Our reference 22-312-20

RE: CALTHORPE STREET, BANBURY – LETTER OF RESPONSE

I am writing further to your Authority's comments dated 19th July 2023 in respect of planning application 23/01633/F, which seeks permission for the redevelopment of retail units & public car park into residential dwellings.

Figure 2 – Proposed Raised Table Crossing

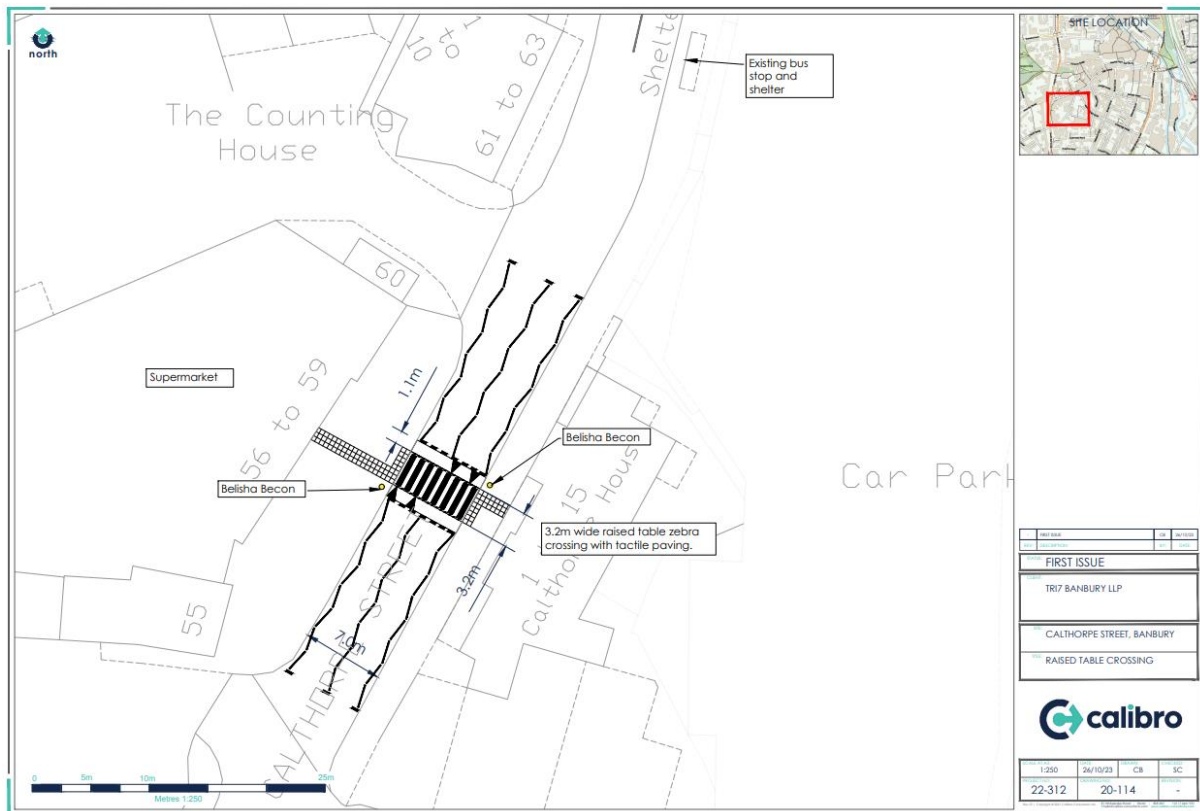
“The Transport Assessment states at 4.3.2 that the ‘local roads are of suitable geometry and sufficiently low vehicular speeds that informal cycling in the carriageway is possible without detriment to highway safety’. While it is expected that the surrounding roads will, subject to consultation, be subject to a 20mph speed limit in the next year or so, even at this speed, traffic volumes are almost certainly above the volumes set out in LTN 1/20 which set a threshold for requiring dedicated space for cycling.

The Oxfordshire LTCP Policy 2b states that ‘We will ensure that all new developments have safe and attractive walking and cycling connections to the site.’ According to the LTN 1/20, infrastructure would be required as mitigation for the site, to provide a safe connection for cyclists.

The Local Cycling and Walking Infrastructure Plan for Banbury is expected to be approved later this week and sets out key routes in Banbury requiring upgrade. Route 1 goes north south along South Bar and North Bar and would be used by residents at the site to access employment sites to the north. Route 2 connects South Bar to Bloxham Road via Crouch Street and would be used as a connecting route to schools. An onward connection along Calthorpe Street would connect this route to the town centre.”

A crossing on Calthorpe Street should be provided, which could be in combination with a raised table junction incorporating access to the council car park. The bus stop on Calthorpe Road should be incorporated into the design, potentially with additional seating, and the shelter should be shown on the drawings and elevations.

On the basis of the above, a raised table crossing is proposed as a way of traffic calming such that the average speed will be in adherence to the 20mph limit. And in so doing, in reference to the traffic flows there will be no need for further cycling improvements. The proposed crossing facility has been appended herewith, and shown below for context.

We trust that the above information and agreement of a level surface crossing across Calthorpe Street address Comment 6 in full.

1.1 Pedestrian and Cycle Connectivity

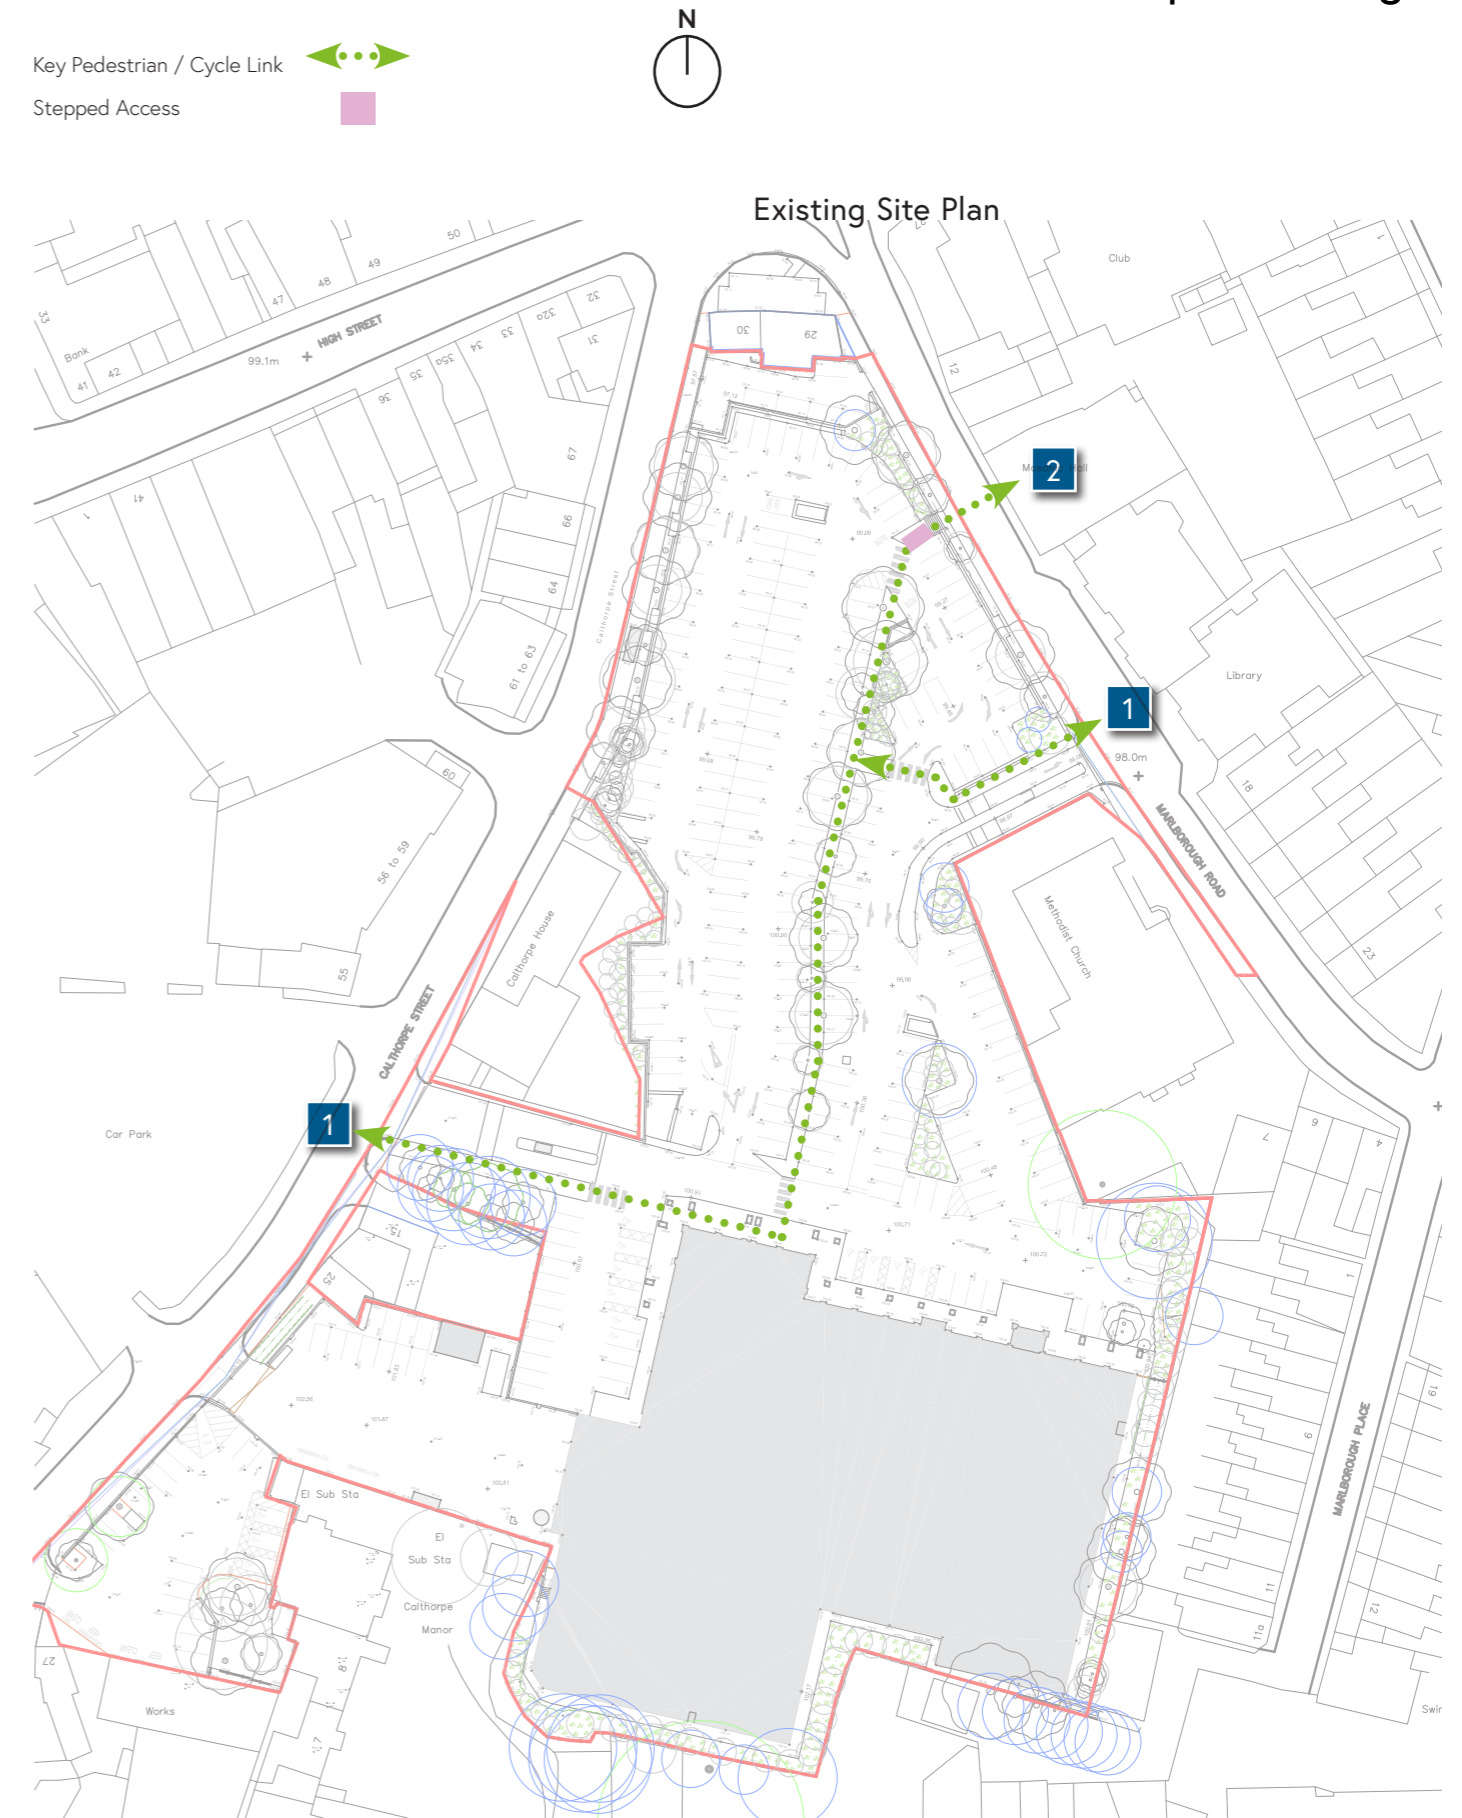
The permeability of the site is welcomed and necessary to encourage walking and cycling. However, it isn't clear whether the southern access onto Calthorpe Road is stepped. It's assumed the access route between Marlborough Road and the northern access onto Calthorpe Road is step-free, but this needs to be clarified. Please provide further clarification of where the steps are. It is stated that there is to be a lift to take people between the landscaped levels in the main north south route through the site. A ramp would be much preferable, as lifts like this are very frequently found out of order.

The access points onto Calthorpe Road should be accessible for cycles, and at least one should allow for cycles to be ridden and should therefore be 3 metres wide. Both accesses currently look too narrow.

We welcome OCC's comments on the permeable nature of the proposed design. In consideration of the location non-car access, Corstorphine & Wright have produced an 'LA Highways Comments – Accessibility Report' – enclosed herewith. Section 1.1 (page 4) details five pedestrian / cycle access points proposed across the site – with Point 1 (Smithy Walk, Marlborough Road) and Point 3 (Manor Gardens) provide both pedestrian and cycle access by way of a shared surface access. With this, the shared surfaces measure at least 6-metres in width and afford access to a limited number of parking spaces and therefore vehicular movements (3 spaces from Point 1 and 9 parking spaces from Point 3). As such, both Calthorpe Street and Marlborough Road provide safe and efficient accesses for bicycles.

To provide further clarity, the southern access from Calthorpe Street is provided as a shared surface ramped access up to blocks A, C, and the town houses. Movement south>north from this access is provided by either steps or a platform lift. As per the appended report, it is considered that the continuous operation of the lift can be guaranteed via a suitably worded condition.

1.3 Deliveries

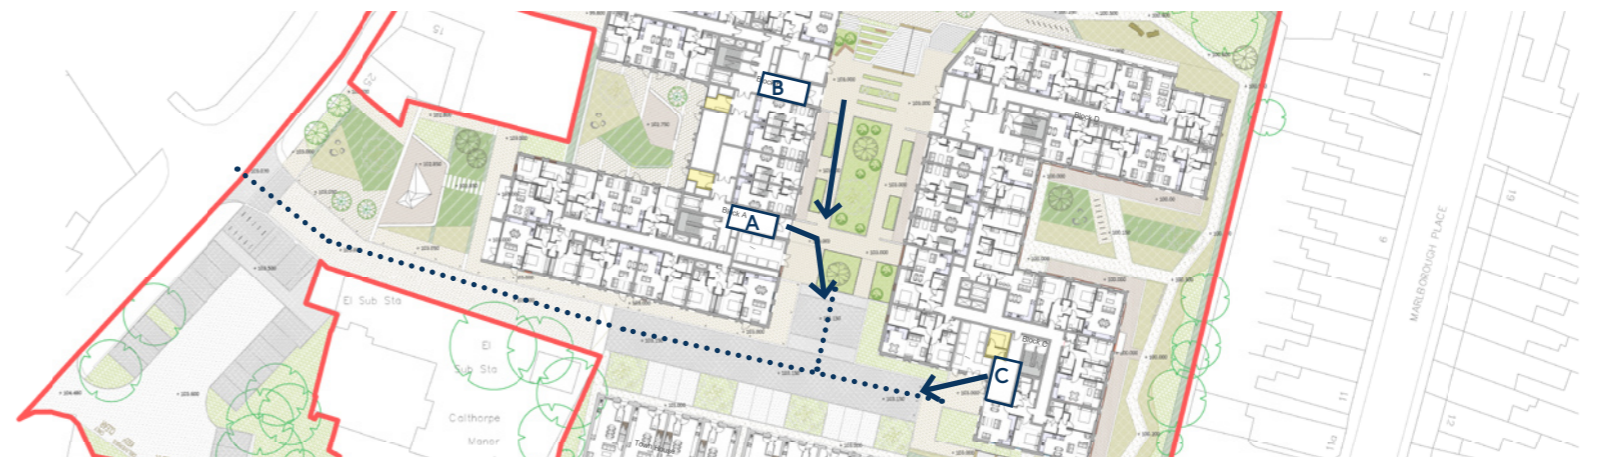
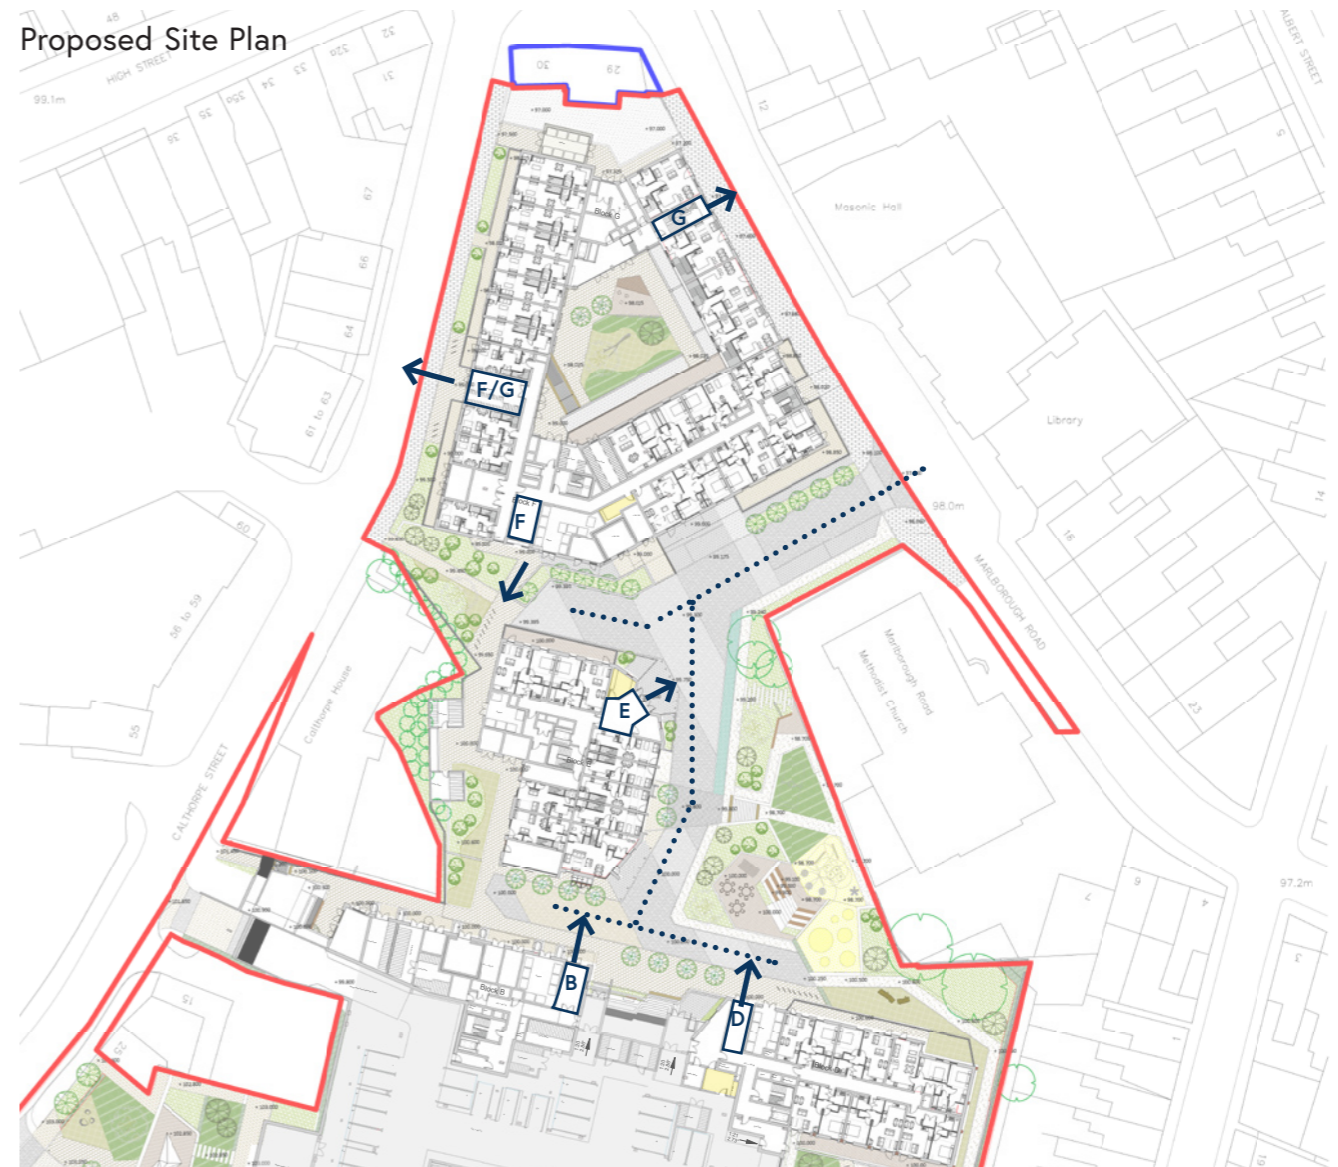
Refuse collection would be from within the development, however bin stores are not labelled on the floor plans.

There should be level or ramped routes for bins and trolleys for deliveries to residents, which do not rely on this external lift.

We have sought to clarify both the refuse and delivery stores and routes in response to the above comments from OCC. With this Corstorphine & Wright have included detailed plans showing refuse and delivery accessibility routes to the respective stores and building entrances across the site within the appended report. For confirmation, all refuse stores and main entrances for deliveries can be accessed step free and do not require use of the external lift proposed within the site.

Blocks A - D

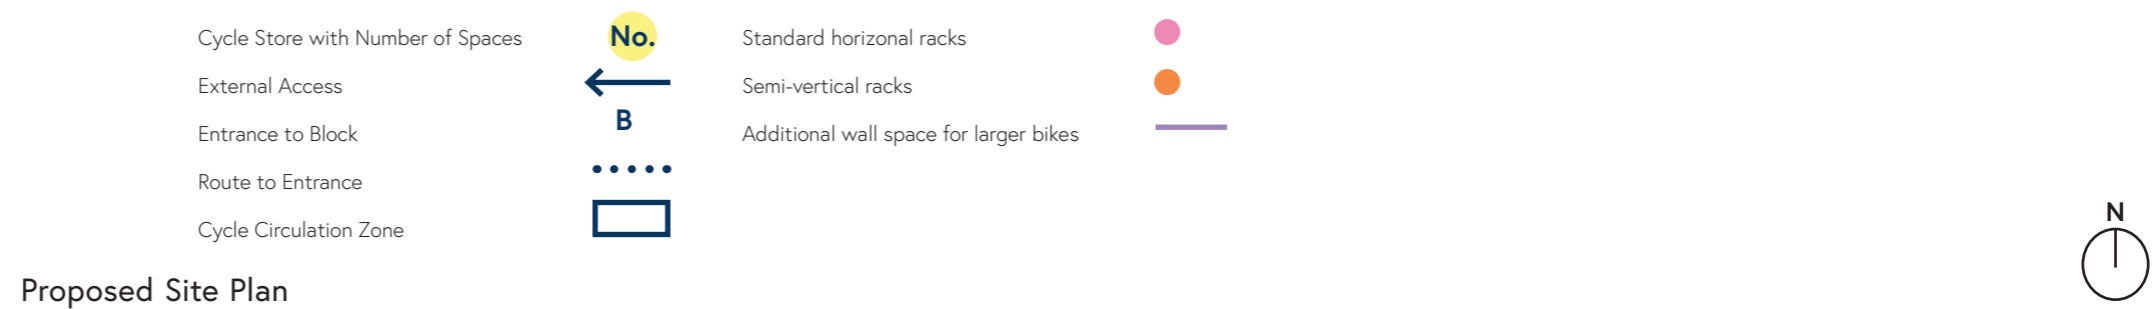
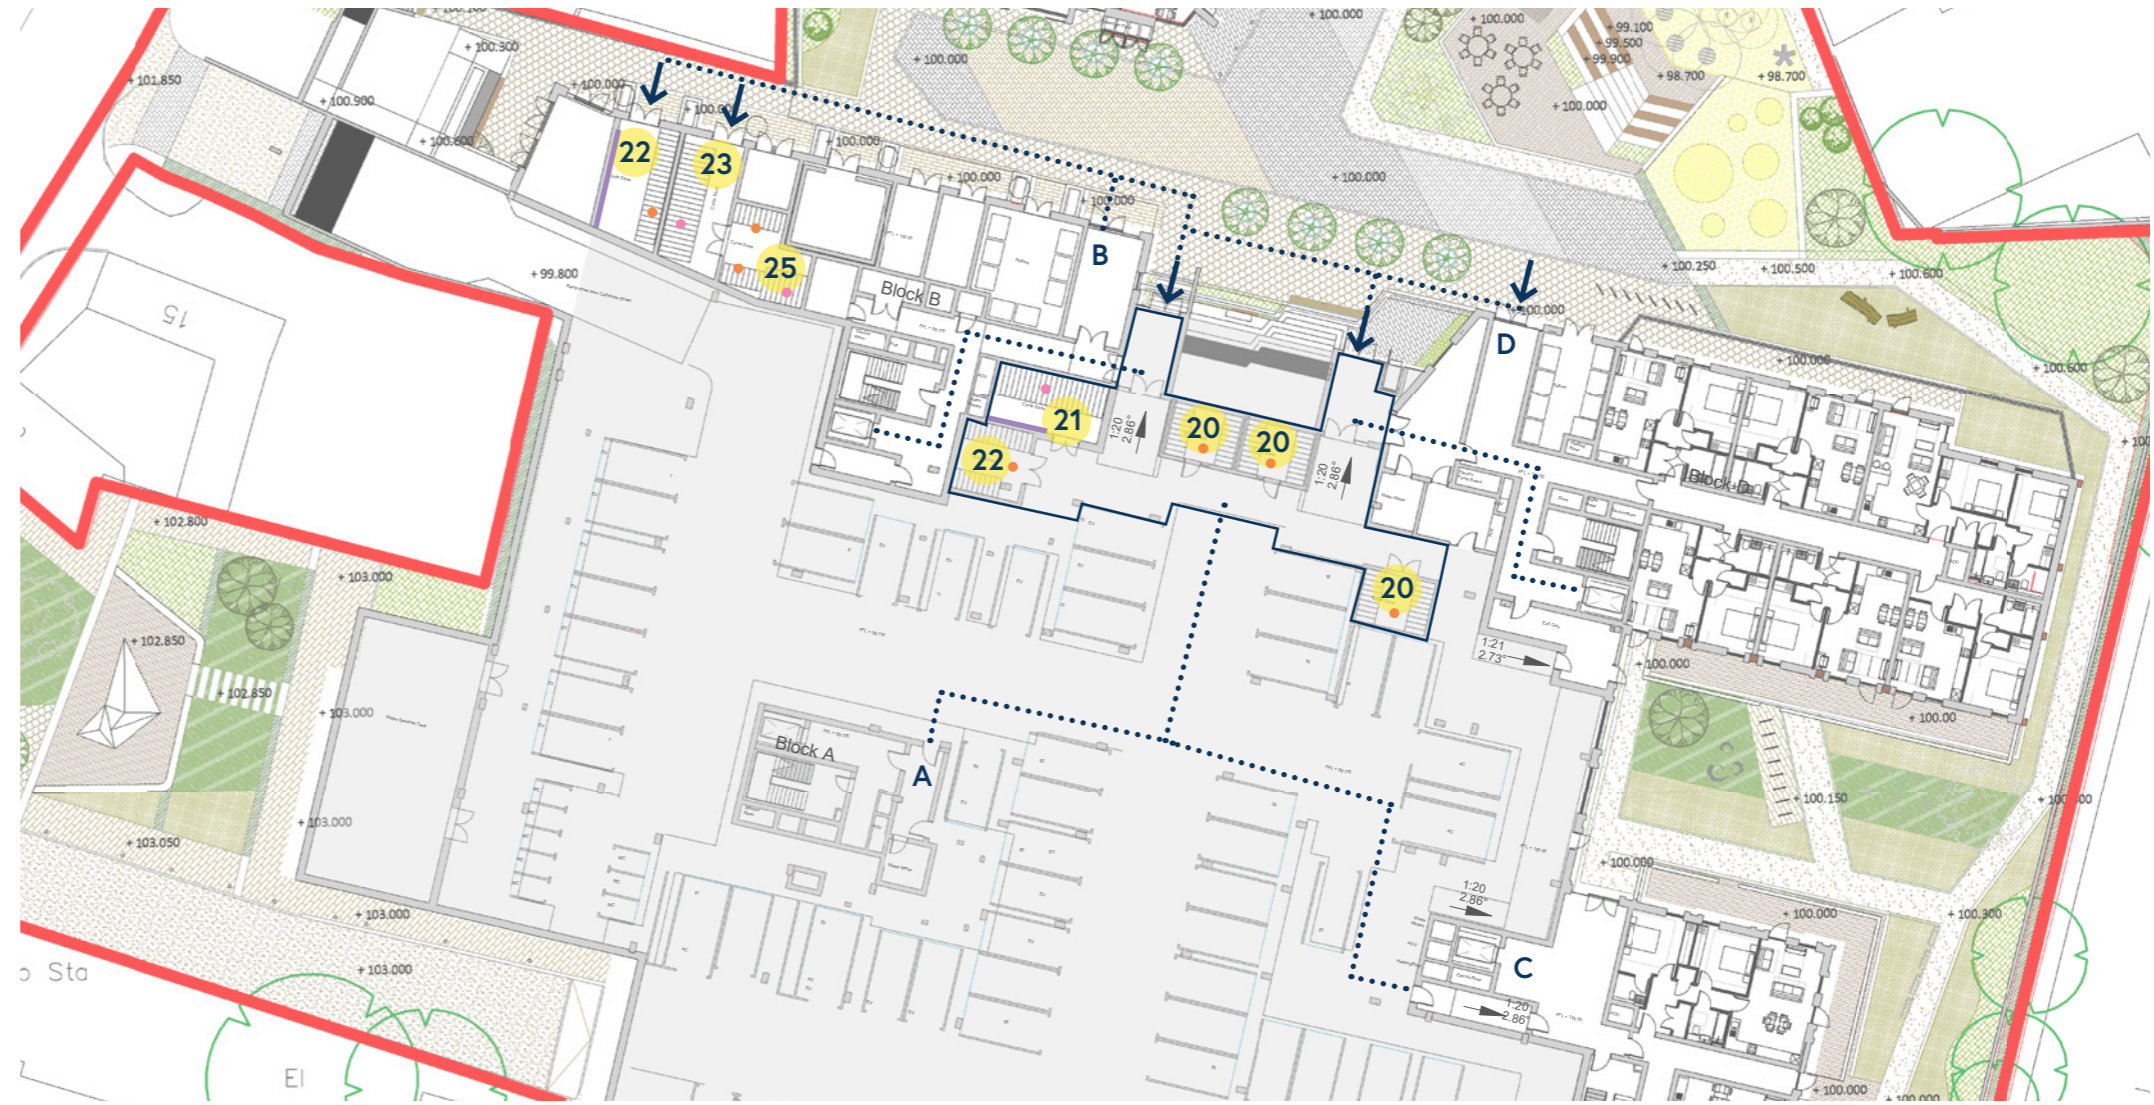
"A number of cycle stores are provided throughout the site, although their location is not clear from the floor plans, on which they are not labelled. Further detail is required to understand exactly where these stores are, how they are accessed, and the type of cycle parking within them. The OCC Parking Standards state that cycle parking should be provided in a convenient location close to building entrances and that the parking should be in the style of a Sheffield stand, not double-decked or vertical unless agreed by OCC in special circumstances."

"Each cycle parking store should provide for e-bike charging."

Following the comments, we have sought to produce plans to clarify the position of cycle stores across the site. With this, Section 1.4 of the appended Corstorphine & Wright Accessibility Report details all proposed locations – with cycle stores conveniently located; close to the building entrances and being directly accessible from outside.

With regards to the design of the cycle parking, the proposals have been amended to provide a mixture of horizontal and semi-vertical racks (91 horizontal and 197 semi-vertical racks), both types of parking available to each residential block. The semi-vertical racks can be provided with electric charging points and as such, each block will be afforded access to electric bike charging spaces.
